## **Issues Raised by the Advisory Committee With Planning Staff Responses**

During the November 17, 2008 meeting of the Landmark/Van Dorn Advisory Committee, members provided City staff with comments on the draft Plan. In addition, Committee members emailed comments to staff. This document contains staff responses to the issues raised by the Advisory Committee.

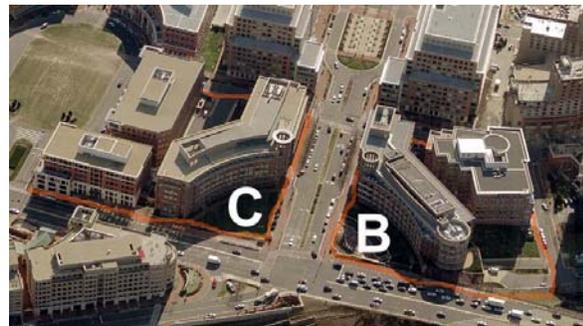
Advisory Committee members asked if developers adjacent to the proposed “High Street” would be able to afford both the dedication of land and the cost of roadway construction. Advisory Committee members also asked for clarity on the issue of the net, or effective, density of development after land dedicated for roadways and other uses has been subtracted.

Planning staff notes that when a developer dedicates land for a roadway, he or she is permitted to use the density associated with that land on his or her remaining parcel. Take, for example, a one-acre parcel with a development potential of 2.0 FAR, or 87,120 square feet. If 10% (4,356 square feet) of the parcel is dedicated for roadways, and another 25% (10,890 square feet) is dedicated as open space, the remaining area of the parcel for development is 28,314 square feet. The developer is still permitted to build 87,120 square feet, even though on a footprint of 28,314 square feet seems like 3.0 FAR ( $87,120/28,314=3.07$ ).

As a real-life example, the Carlyle development meets an overall gross floor area requirement of 2.0 FAR. The map below shows a portion of Carlyle: Blocks B and C along Duke Street. Taking out open space, the net or effective FAR on Block B is 4.7 and on Block C is 4.4. Parking is underground.

Retaining this density provides financial relief to developers who are required to dedicate land. In addition, the new roadways required in the draft Plan add value to the remaining land by increasing access and visibility of the new development. It is typical to require new development to build internal and adjacent roadways. However, staff is not expecting private development to pay for the major roadway improvements to Van Dorn Street and Duke Street.
